7.6 All Other Instrumentation Systems Required for Safety

The information in this section of the reference ABWR DCD, including all subsections, tables, and figures, is incorporated by reference with the following departures and supplements.

Figure 7.6-4a Basic Configuration of a Typical Neutron Monitoring System Division

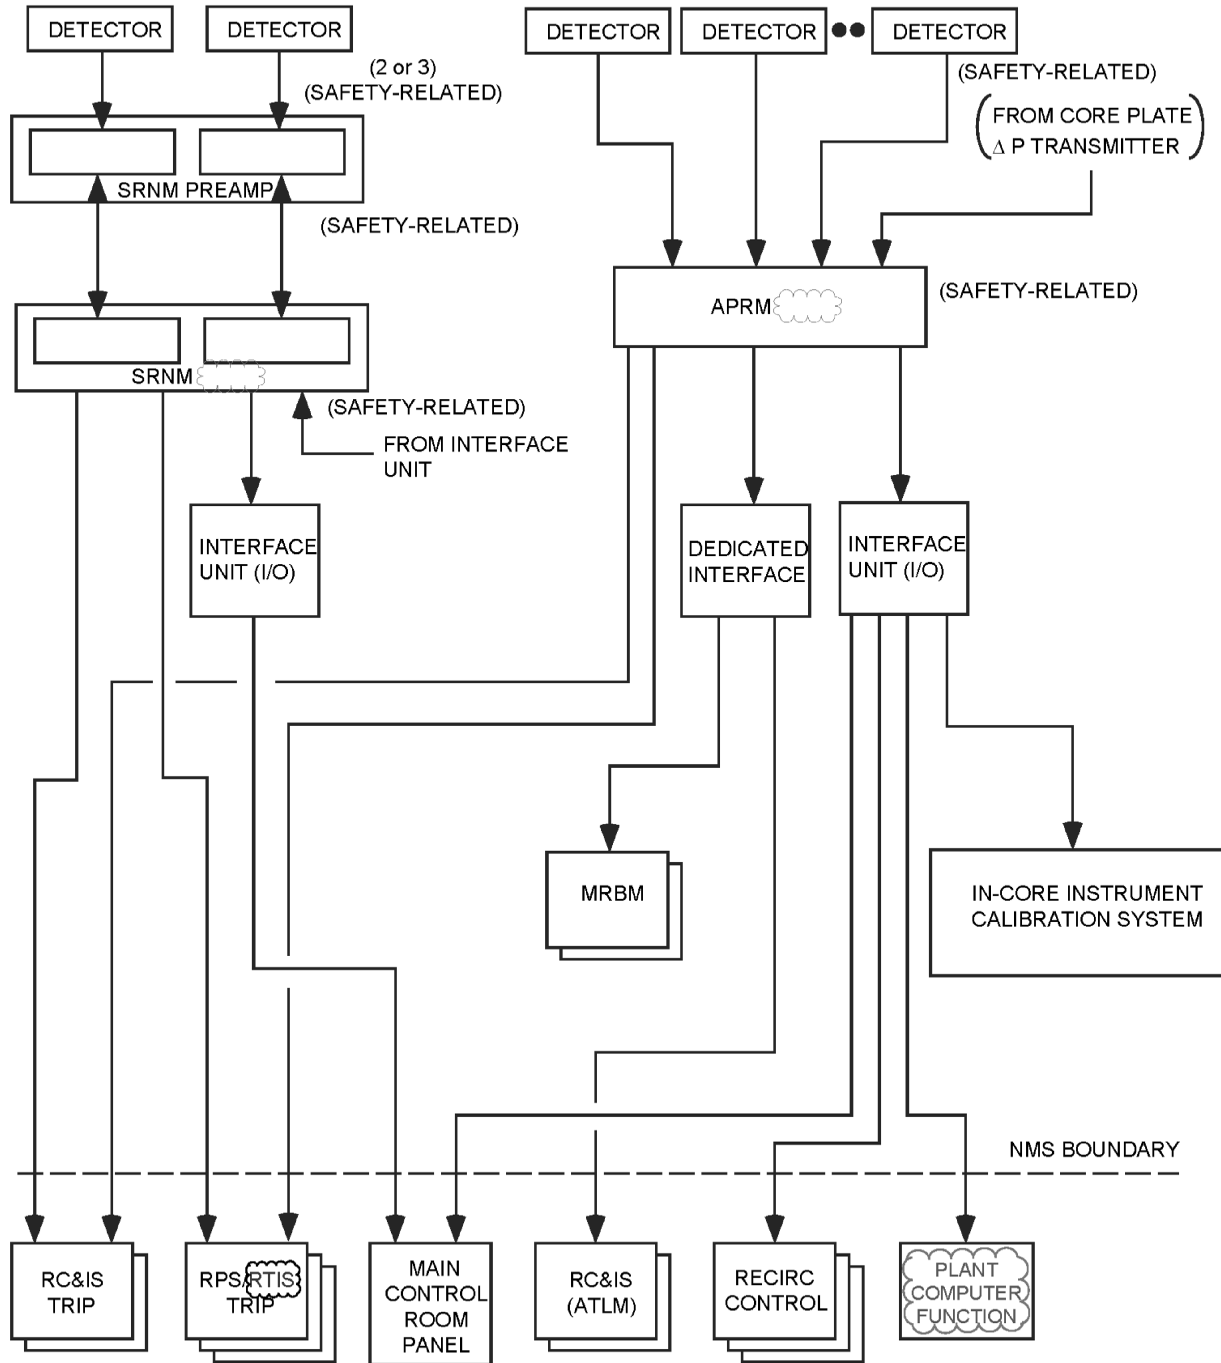
STD DEP T1 3.4-1 (Table 7.6-5 and Figures 7.6-1, 7.6-2, 7.6-4a)

The purpose of the Neutron Monitoring System (NMS) is to monitor power generation and, for the safety function part of the NMS, to provide trip signals to the Reactor Protection System (RPS) to initiate reactor scram under excessive neutron flux (and power) increase condition (high level) or neutron flux fast rising (short period) condition. The NMS also provides power information of operation and control of the reactor to the Plant Process Computer System (PCS) Functions (PCF) and the rod block monitor. A block diagram showing a typical NMS division is shown in Figure 7.6-4a. The operating ranges of the various detectors are shown in Figure 7.6-4b.

Figure 7.6-9 Instrumentation Location Definition for the Suppression Pool Temperature Monitoring System

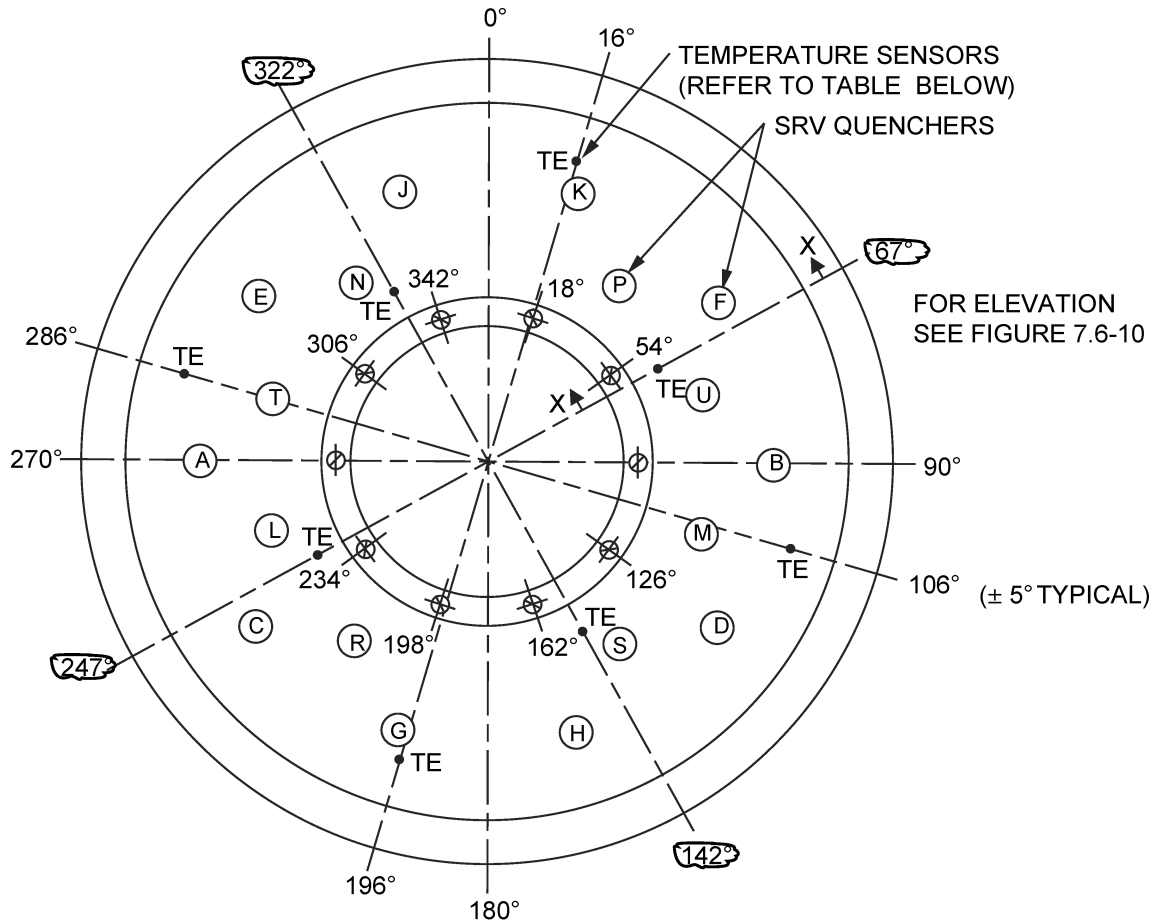
STD DEP 7.6-3 (Figures 7.6-9, 7.6-11)

The SPTM System configuration is shown in Figures 7.6-9 and 7.6-10. There are eight temperature circumferential sensor locations (Figure 7.6-9), which are chosen based upon the following considerations:

- (2) Each SRV discharge line quencher is in direct sight of two sets of temperature sensors within 9 meters.

Figure 7.6-14 OPRM Logic

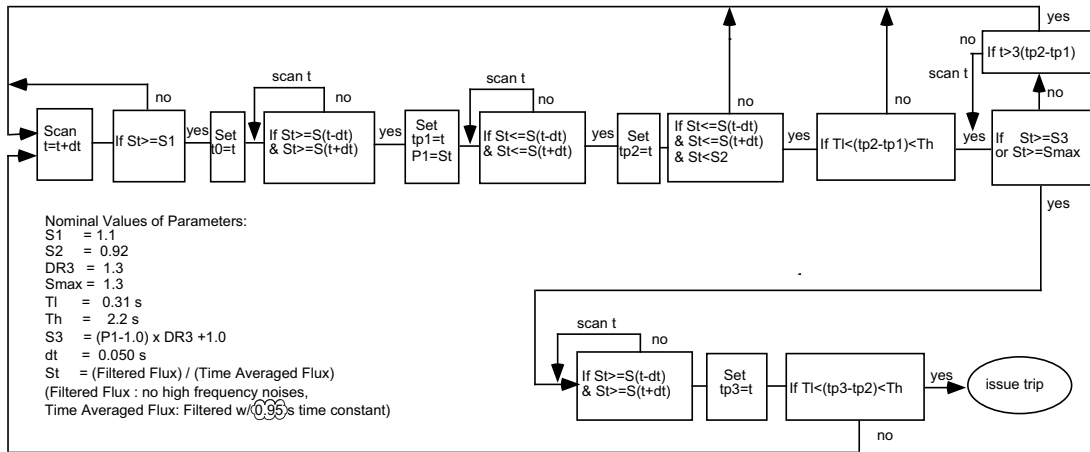
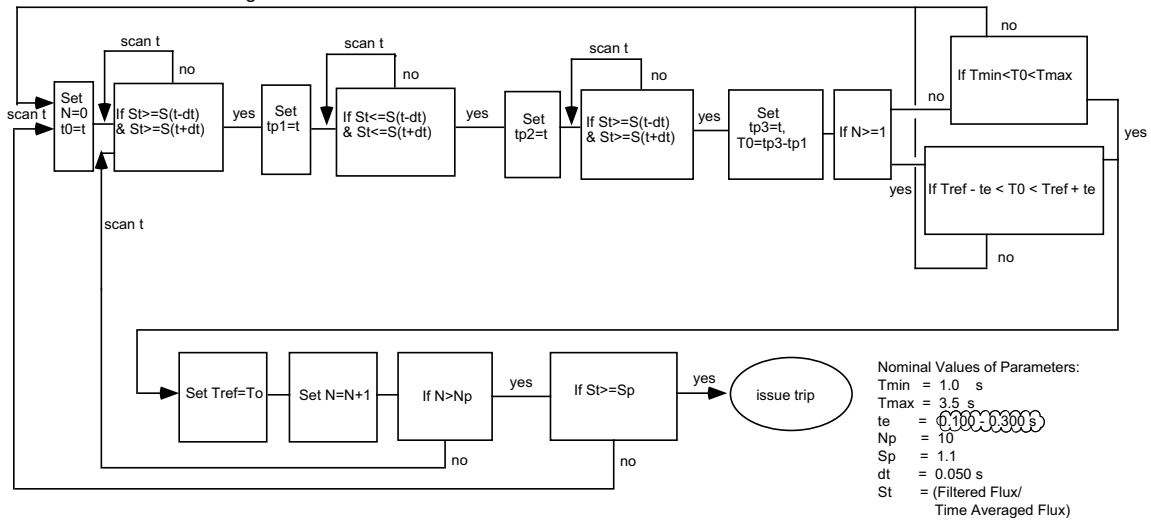
STD DEP 7.6-1 (Table 7.6-2 and Figures 7.6-2, 7.6-14)

For the OPRM trip function, the response signal of any one OPRM cell that satisfies the conditions and criteria of the trip algorithm will cause a trip of the associated OPRM channel. Figure 7.6-14 illustrates the trip algorithm logic. ~~The OPRM trip function does not have its own inoperative trip for insufficient number of total LPRM inputs in the channel. It follows the APRM's inoperative trip of insufficient number of LPRMs.~~ The OPRM function has its own inoperative trip when the channel has less than the required minimum operable cells, when there is an OPRM self-diagnostic fault, when the APRM instrument watchdog timer has timed out, or if there is a loss of power to the APRM instrument.

$T_{\min}=1$ s, $T_{\max}=3.5$ s, $\pm t_{\text{error}}=0.15$ s **[0.100 - 0.300s]**, $N_P=10$.
 (For details see Figure 7.6-14).
